CASE NO. UDP-S24005

CASE:	UDP-S24005
MEETING DATE:	February 27, 2024
REQUEST:	Site Plan Level III Review: Conditional Use for Building Height above 150 Feet, Waterway Use, and Yard Modification Request for 44-unit Multifamily Development
APPLICANT:	900 Intracoastal Drive, LLC.
AGENT:	Courtney Crush, Crush Law, P.A.
PROJECT NAME:	900 Intracoastal
PROPERTY ADDRESS:	900 Intracoastal Drive
ZONING DISTRICT:	Residential Multifamily High Rise/High Density (RMH-60)
LAND USE:	High Density Residential
COMMISSION DISTRICT:	1 - John Herbst
NEIGHBORHOOD ASSOCIATION:	N/A
CASE PLANNER:	Yvonne Redding

Case Number: UDP-S24005 – 900 Intracoastal Drive

UDP-S24005 - 900 INTRACOASTAL DR.

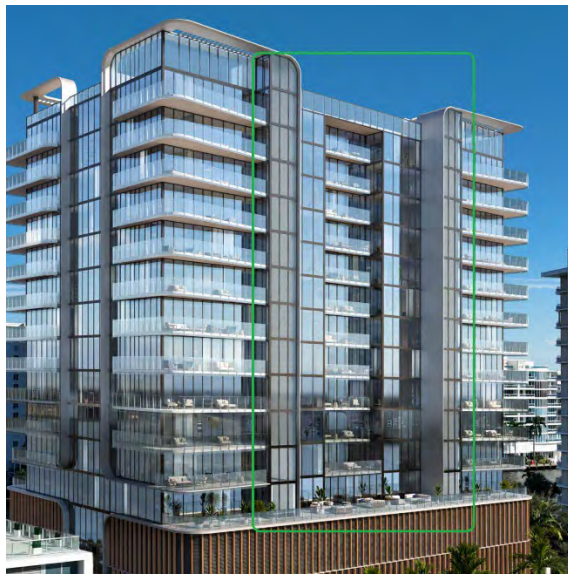
13. Discuss and consider the following design modifications:

- a. In order to allow for greater interplay of light and air, step back the tower to create a more slender tower perpendicular to the shoreline.
- b. In order to bring visual interest and break up the massing on the east façade, provide similar façade treatment as provide on the west façade facing Intracoastal Drive. Provide on the east façade a similar tower setback located at the center of the building facing west (image below).
- c. Additional fenestration and articulation should be added to the ground floor level facing north and south.

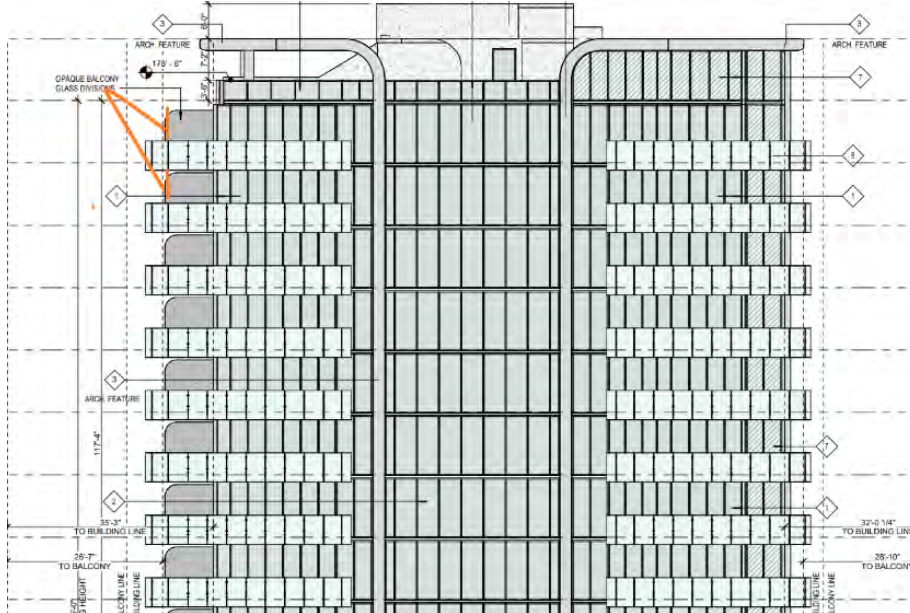
14. Provide the following changes on elevations:

- a. Accurately measurement to the edge of balconies.
- b. The proposed building line should be measured to the opaque glass dividers on the balconies as these are not deemed architectural features.

- c. Accurately depict the proposed partitions between the units on the renderings. Provide details of opaque glass dividers.
 - d. In order to show correct height of building, indicate ground floor elevation as per FEMA regulations and dimension to top of roof level railing as roof is designed for habitable space.
